To: T13 Technical Committee
From: Rob Elliott, HP (elliott@hp.com)
Date: 6 November 2009
Subject: e09150r0 EDD-4 Hybrid MBR partition records annex

GPT support for hybrid MBR partition records

Figure B.1 — GPT disk layout with hybrid MBR partition records example

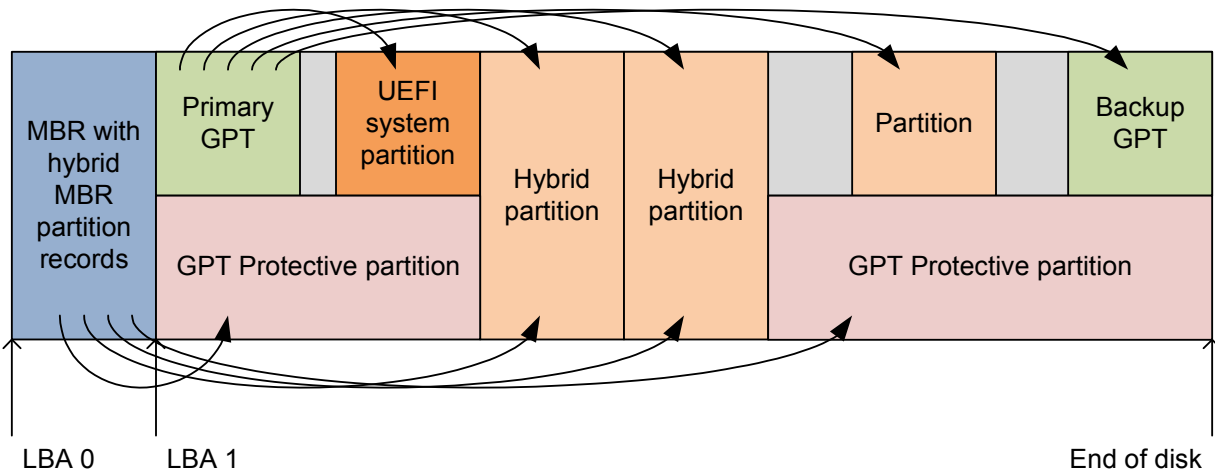
- a) legacy MBR boot code;
- b) one partition record protecting the Primary GPT and the UEFI system partition;
- c) one partition record pointing to a hybrid partition (i.e., a partition pointed to by both MBR and GPT partition tables) containing legacy VBR boot code. The hybrid partition is located below LBA FFFFFFFh so it is addressible via the MBR partition record; and
- d) additional partition records pointing to additional hybrid partitions, or protecting the remaining capacity of the disk.

Figure B.1 shows an example of hybrid MBR partition records.

Figure B.2 — GPT disk layout with hybrid MBR partition records truncation example

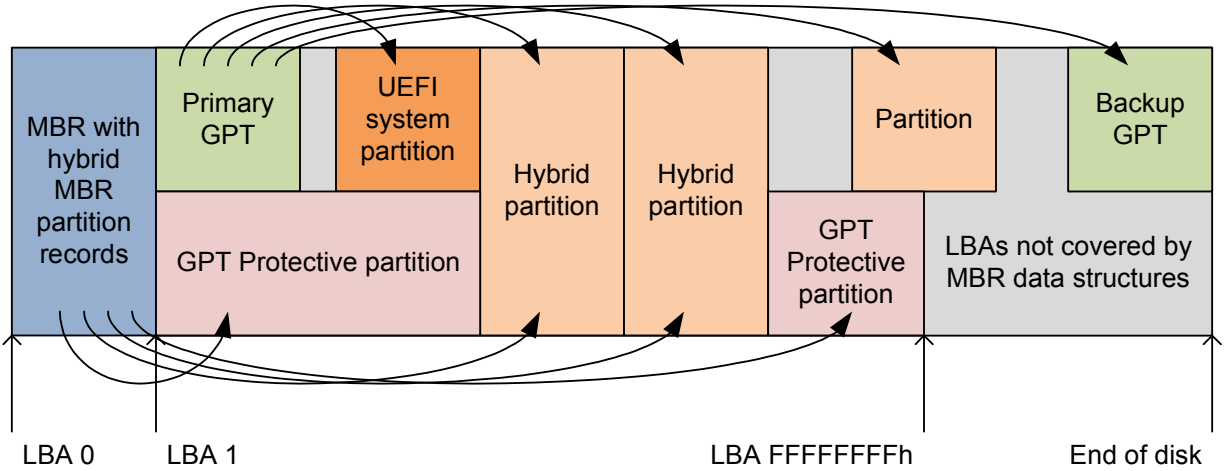
Figure B.1 shows an example of hybrid MBR partition records on a disk with an ending LBA greater than FFFFFFFFh. The MBR partition records are not able to describe the LBAs above FFFFFFFFh.
